# FAA 7100.41 Design Team Outcomes and Conceptual Procedures

Presentation to: DC Metroplex BWI Community Roundtable

Date: April 24, 2018

# BWI ANTHM RNAV STAR (Arrival)

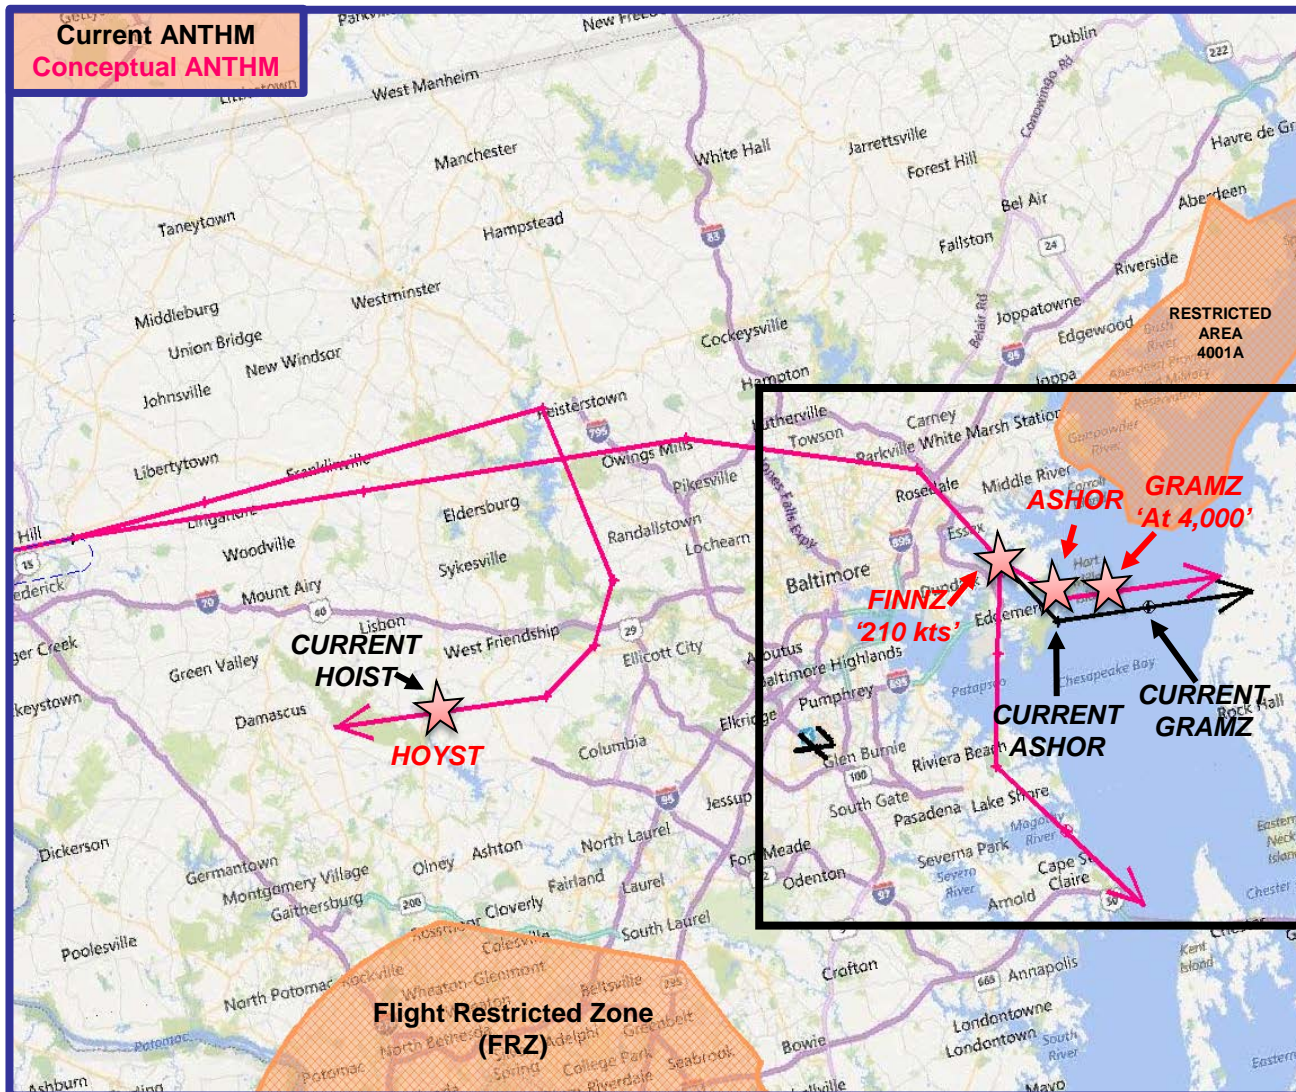
- Serves jet arrivals from the west
- Runway 28 Usage:
  - ✓ 4.8% (6,223 flights/year)
- Spelling change – HOIST to HOYST
- Runway 28 Changes:
  - ✓ Added 210 kts speed restriction at FINNZ for criteria
  - ✓ Moved ASHOR and GRAMZ 0.9 nm north to provide a 4-mile downwind to RWY 28
  - ✓ Moved 4,000 ft altitude restriction from ASHOR to GRAMZ for criteria

# BWI TRISH RNAV STAR (Arrival)

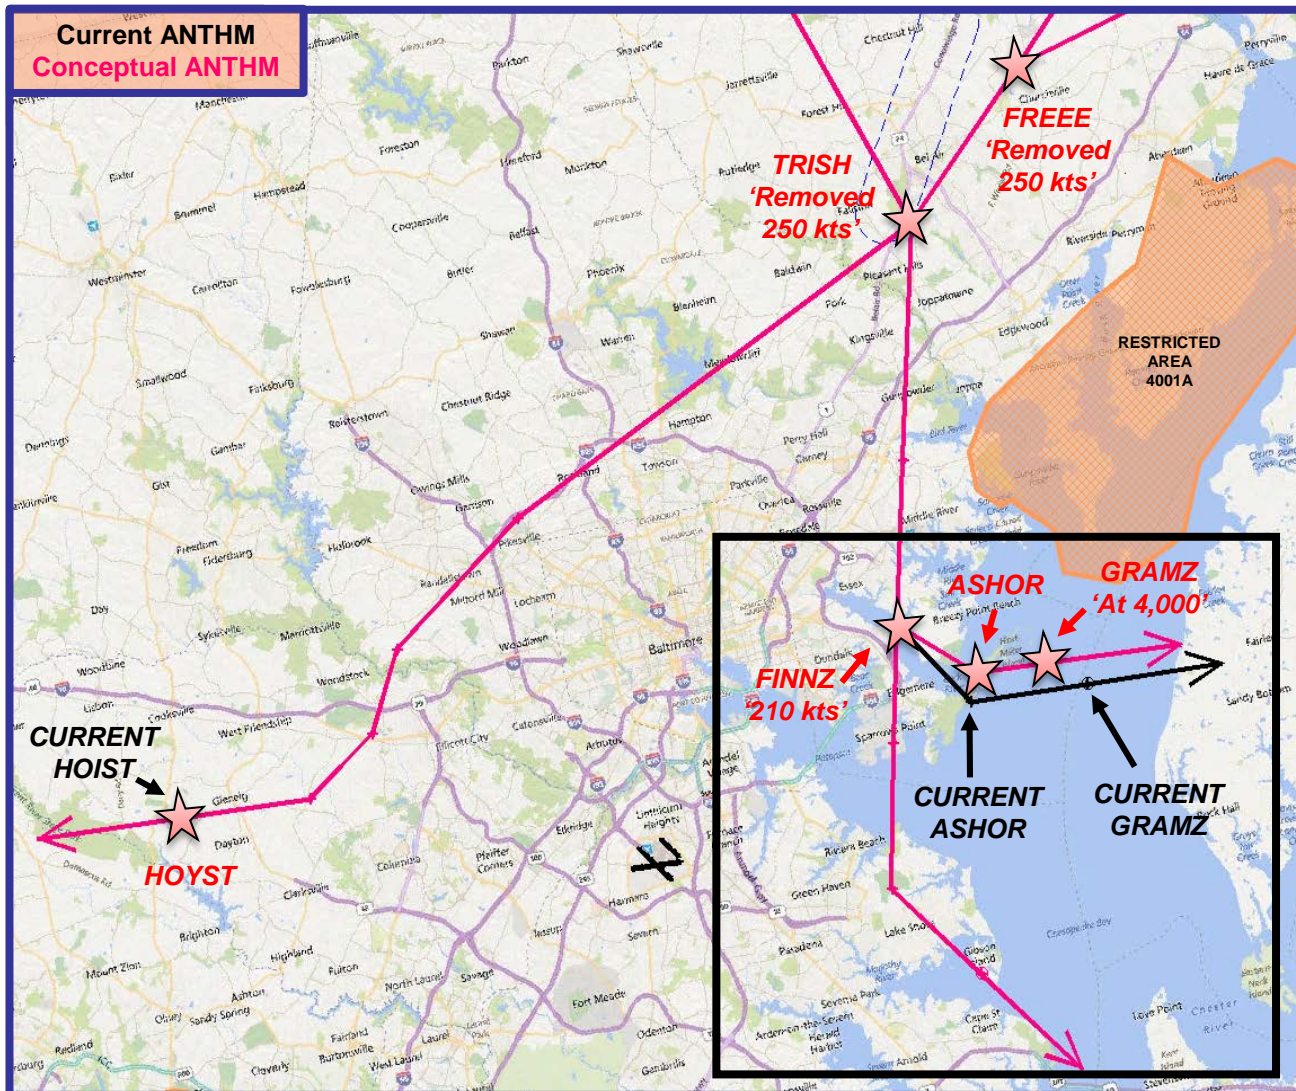
- Serves jet arrivals from north
- Runway 28 Usage:
  - ✓ 4.8% (6,223 flights/year)
- Spelling change – HOIST to HOYST
- Runway 28 Changes:
  - ✓ Added 210 kts speed restriction at FINNZ for criteria
  - ✓ Moved ASHOR and GRAMZ 0.9 nm north to provide a 4-mile downwind to RWY 28
  - ✓ Moved 4,000 ft altitude restriction from ASHOR to GRAMZ for criteria
- Removed 250 kts speed restriction at FREEE and TRISH for criteria

# BWI MIIDY RNAV STAR (Arrival)

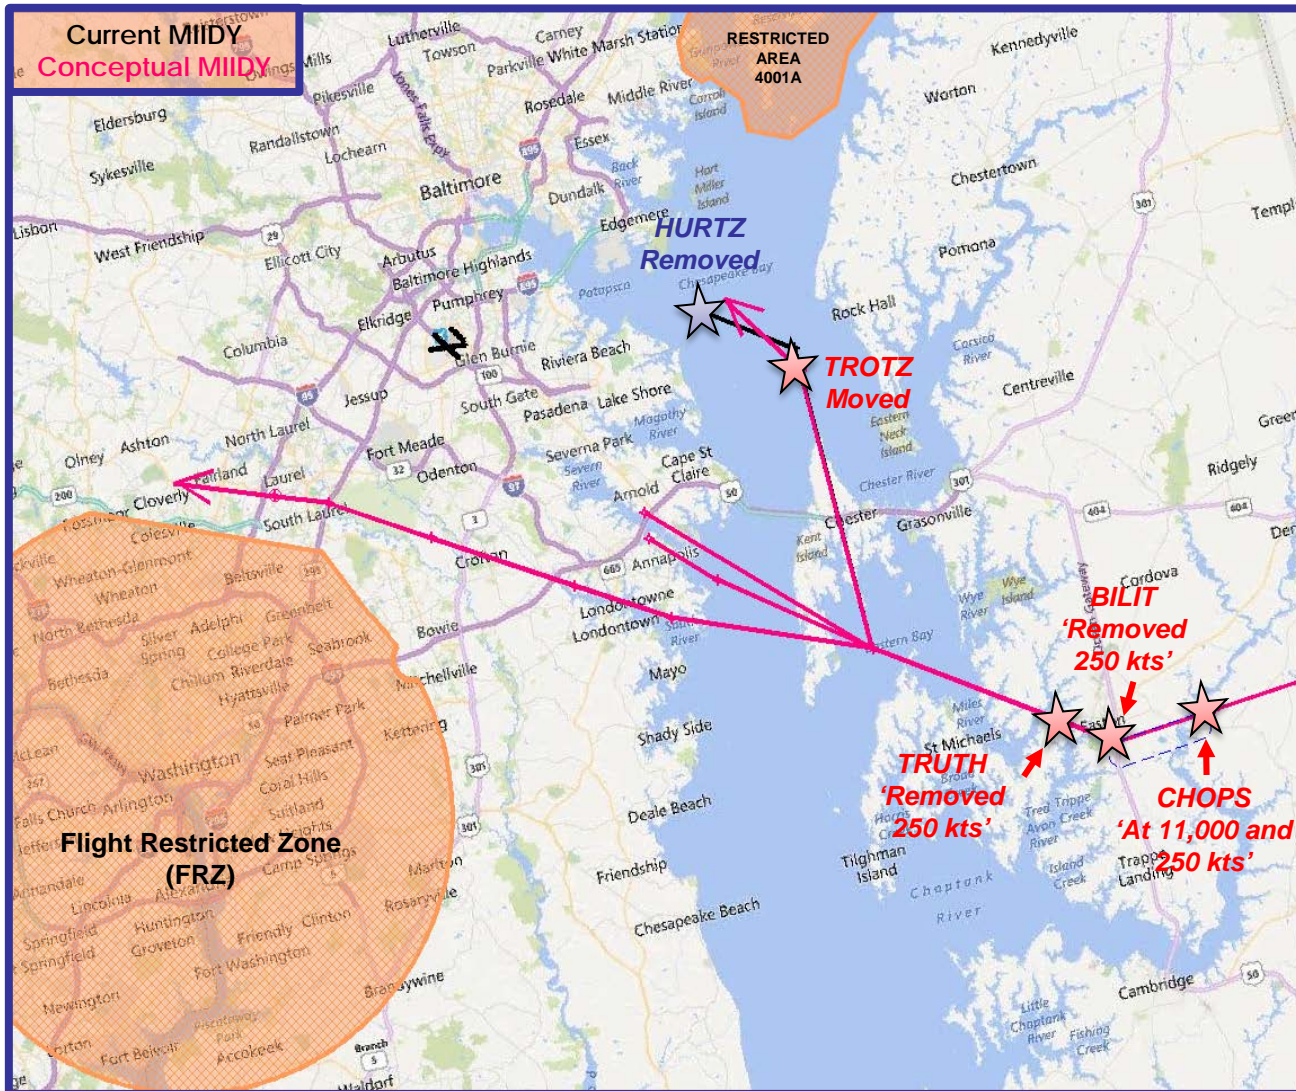
- Serves jet arrivals from the southeast
- Runway 28 Usage:
  - ✓ 4.8% (6,223 flights/year)
- Added 11,000 ft and 250 kts speed restriction at CHOPS to match existing agreements between Washington Air Route Center (ZDC) and Potomac TRACON (PCT)
- Removed 250 kts speed restrictions from BILIT and TRUTH to avoid redundancy
- Runway 28 Changes:
  - ✓ Removed HURTZ
  - ✓ Moved TROTZ 1 nm southeast to help with RWY28 sequencing
